RFB-2024-19
SUNY SCCC MOBILE LAB GARAGE
C2 DESIGN GROUP

ADDENDUM #1

Issued Date: 6/18/2024

FLOOR PLAN
 Sheet Number:
A101

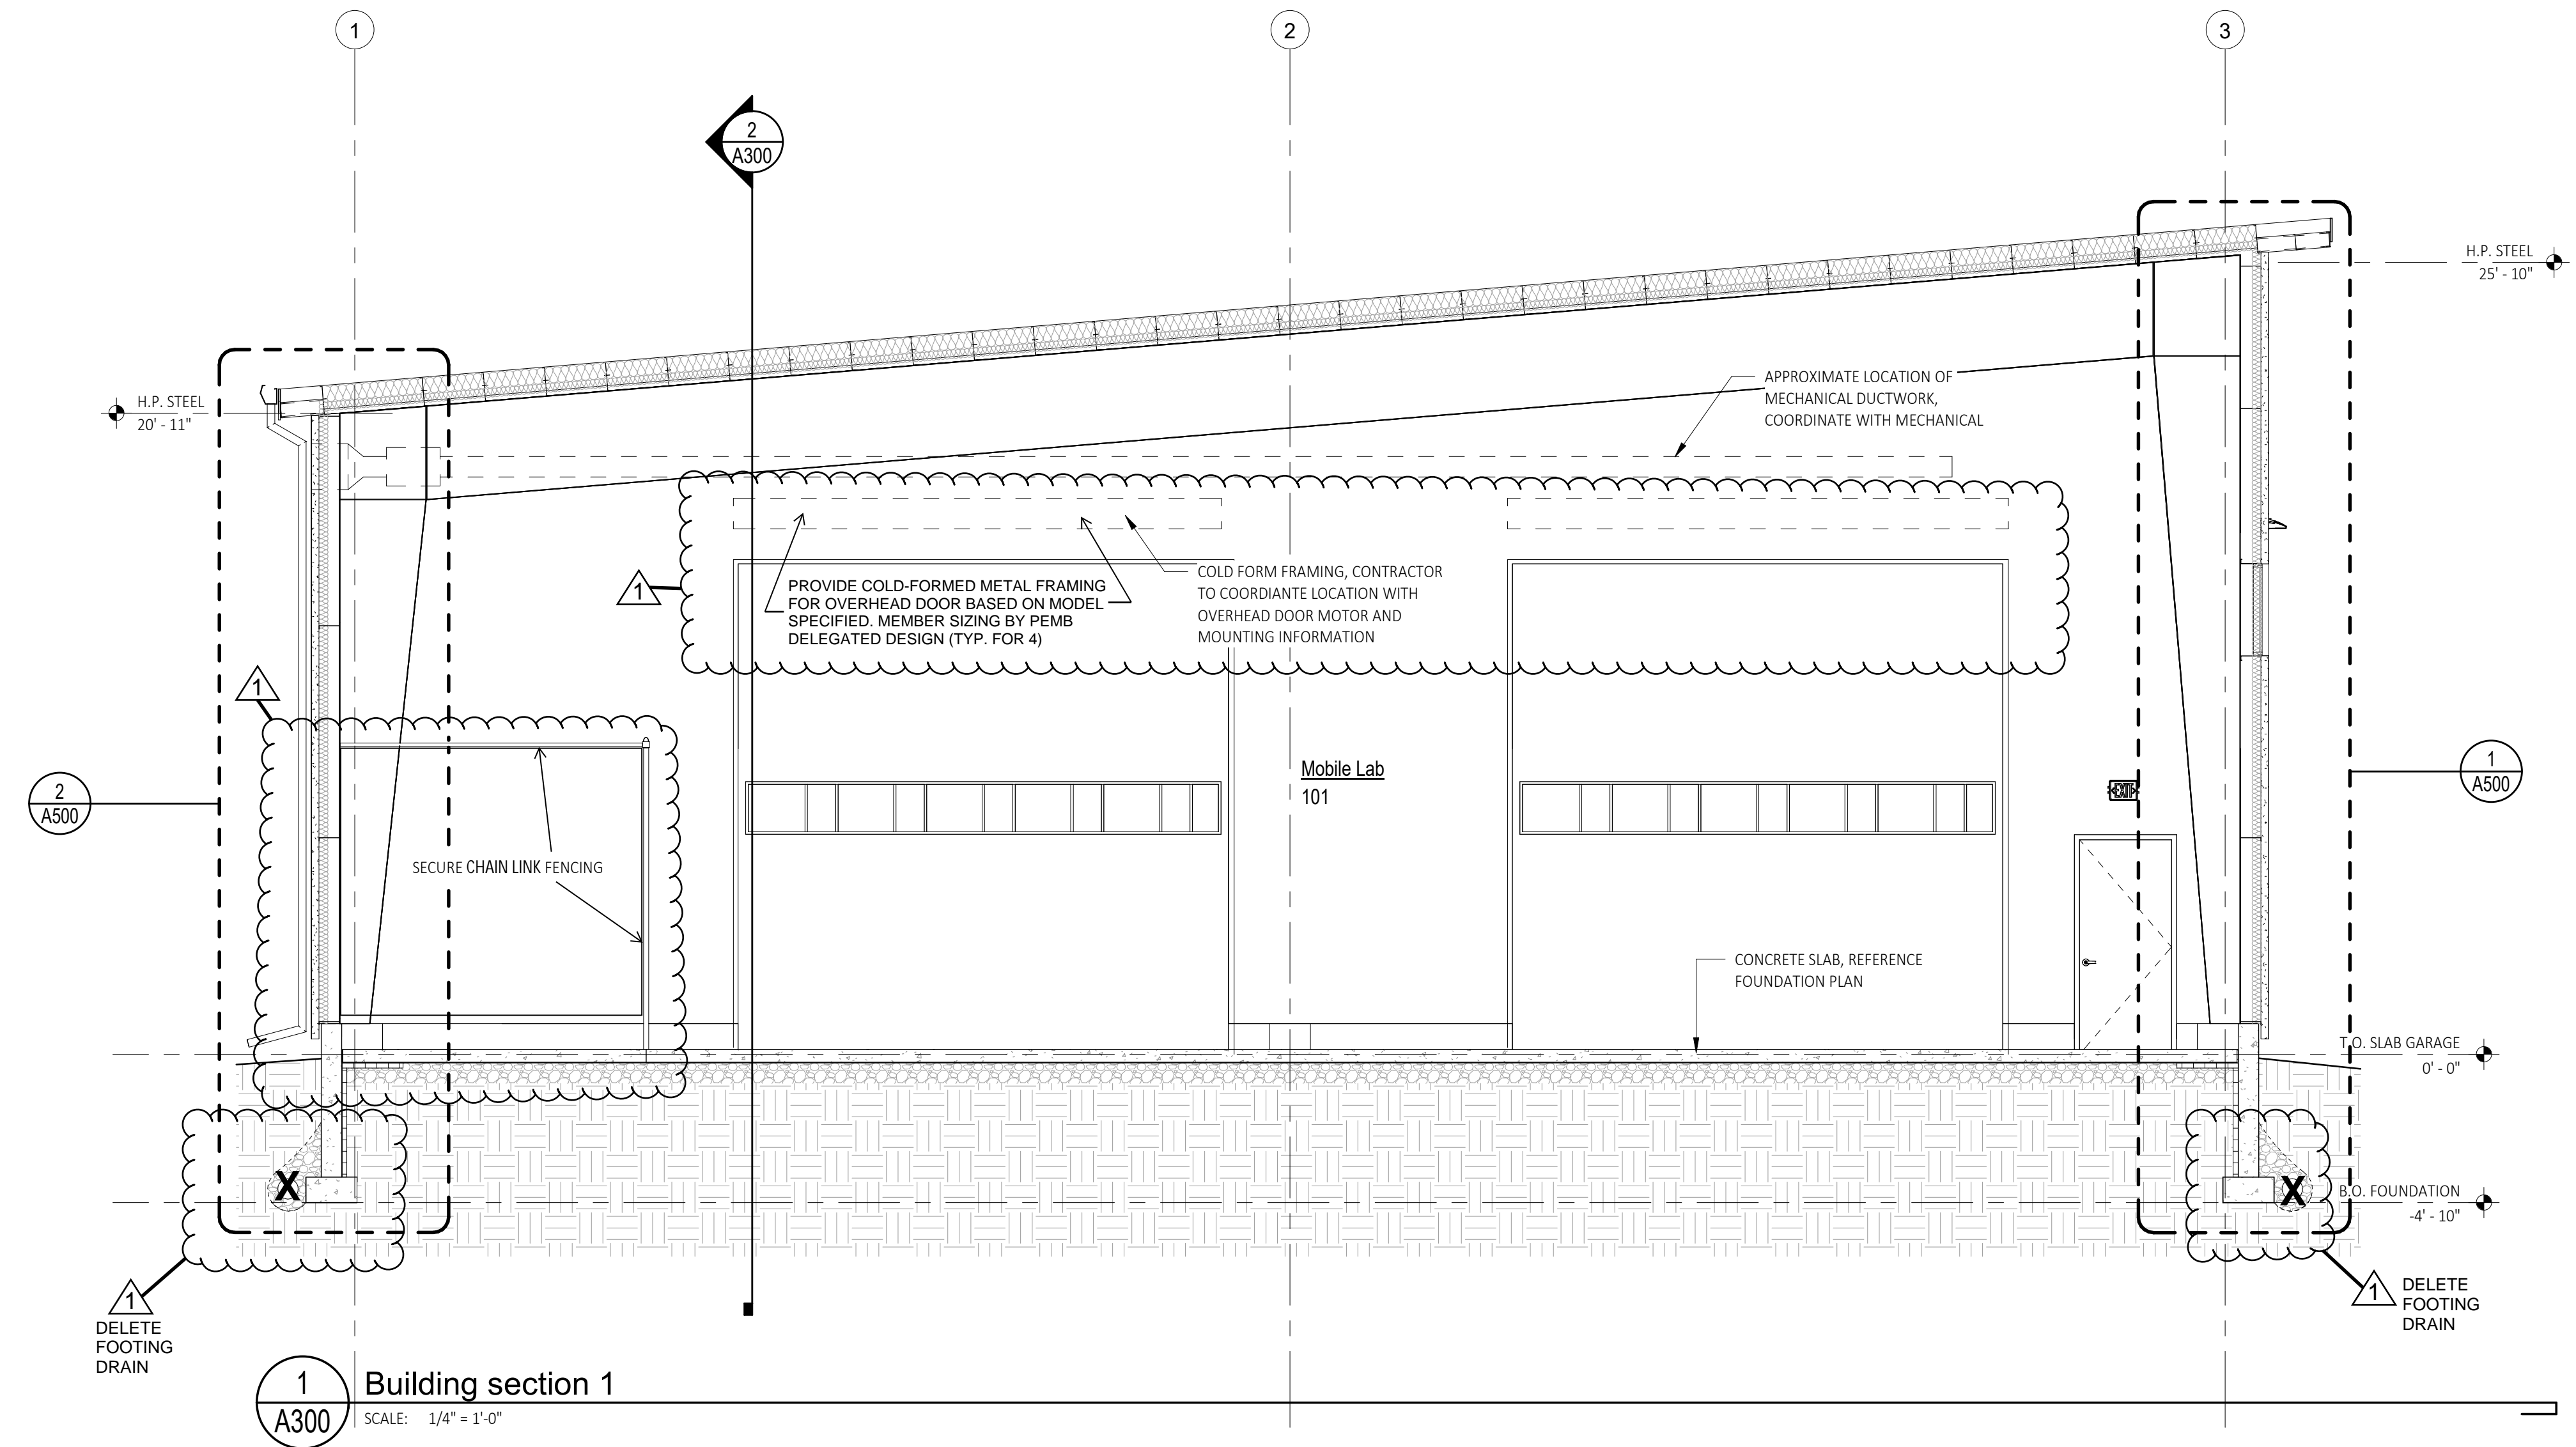
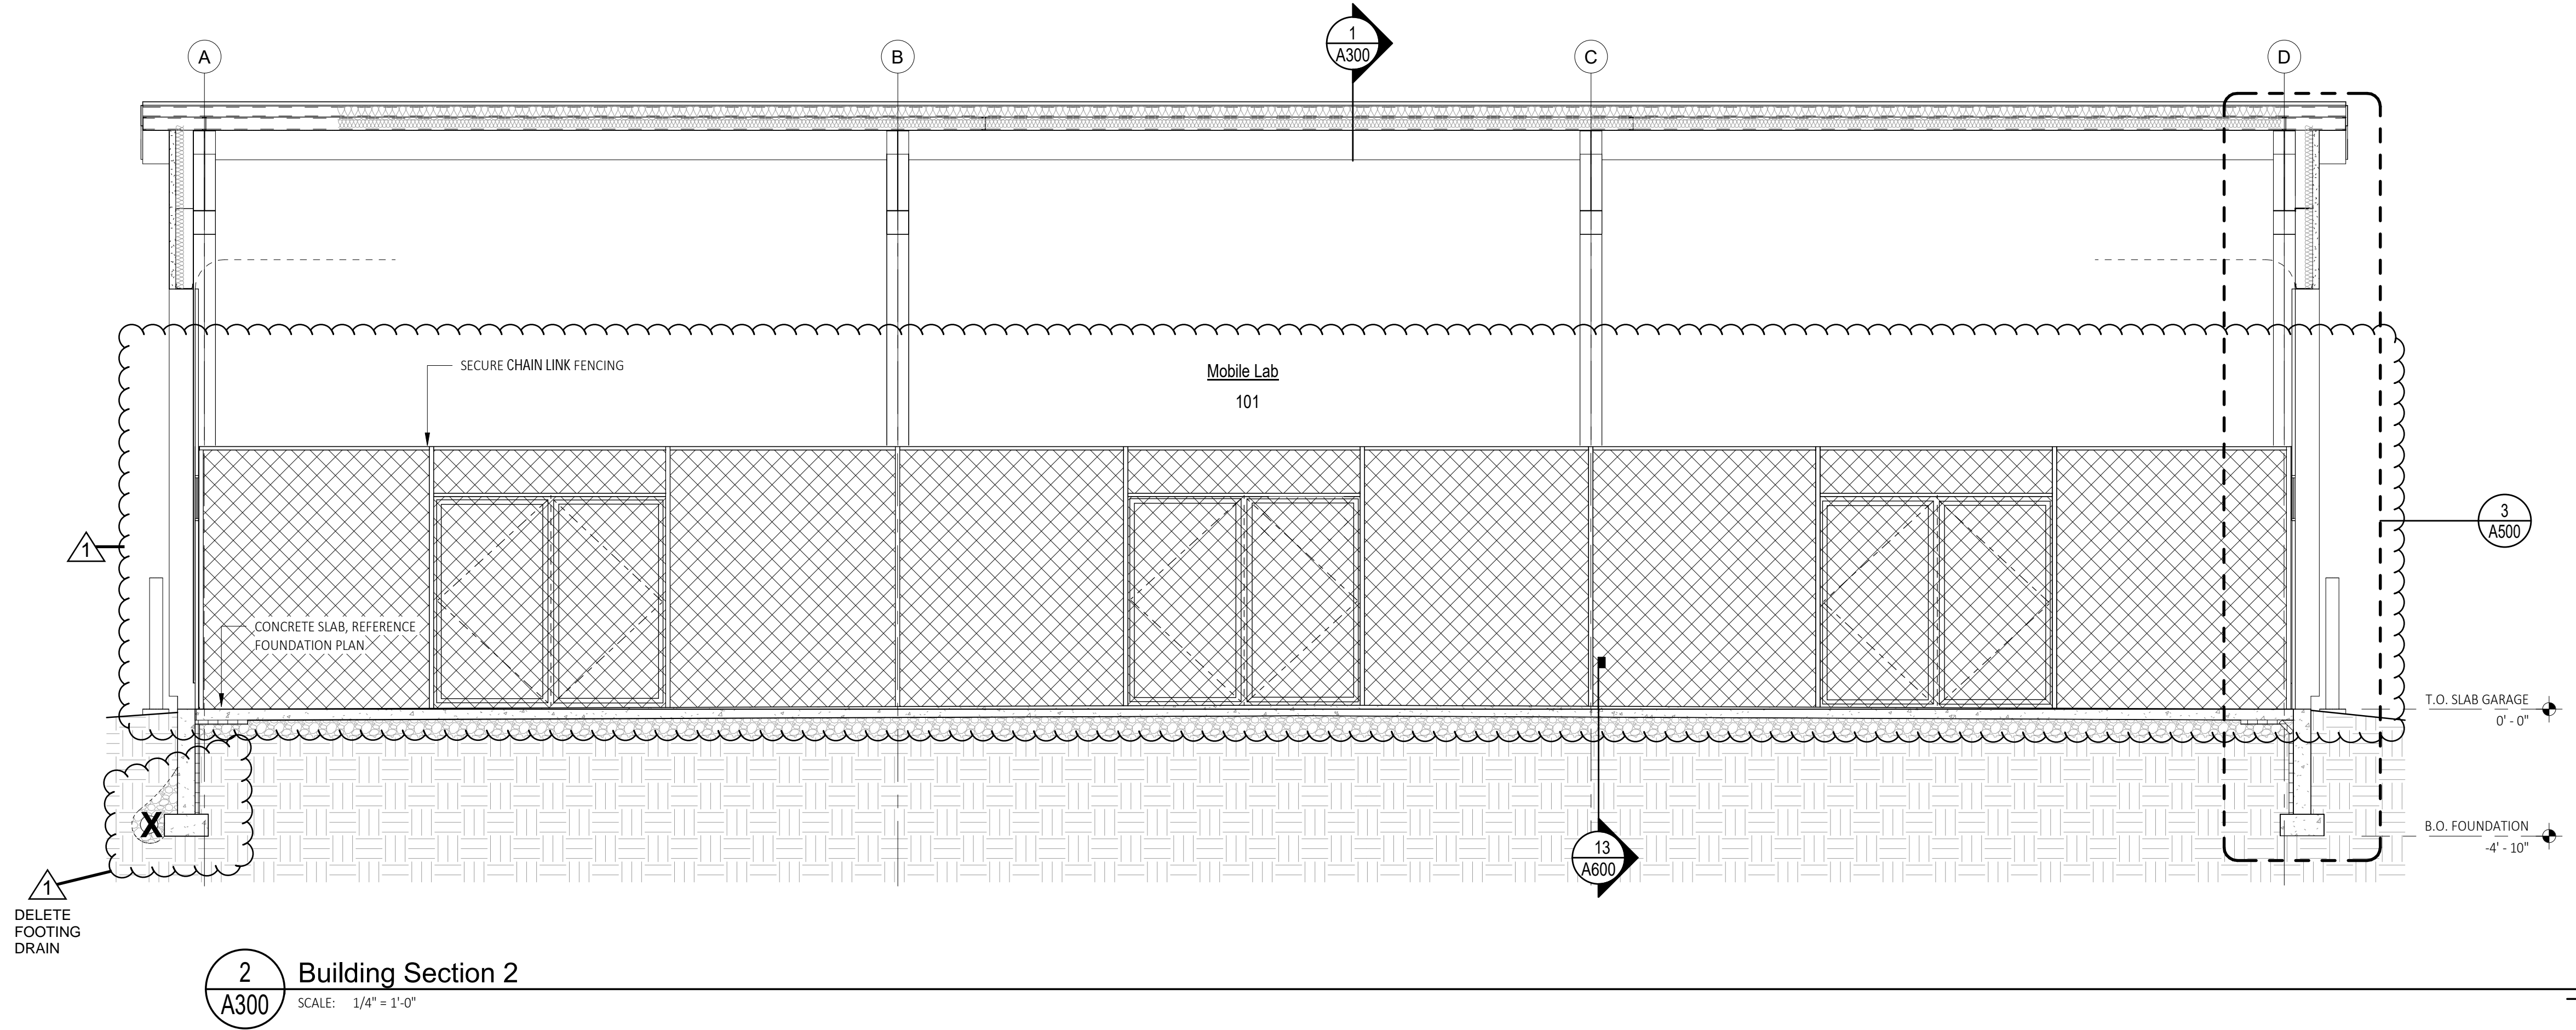
- a. A: Vapor retarders shall be 15 mil as specified in section 0330002.7.A.
10. Q: No slab control joint/sealing details and locations are provided.
 - a. See revised sheet A101, attached.
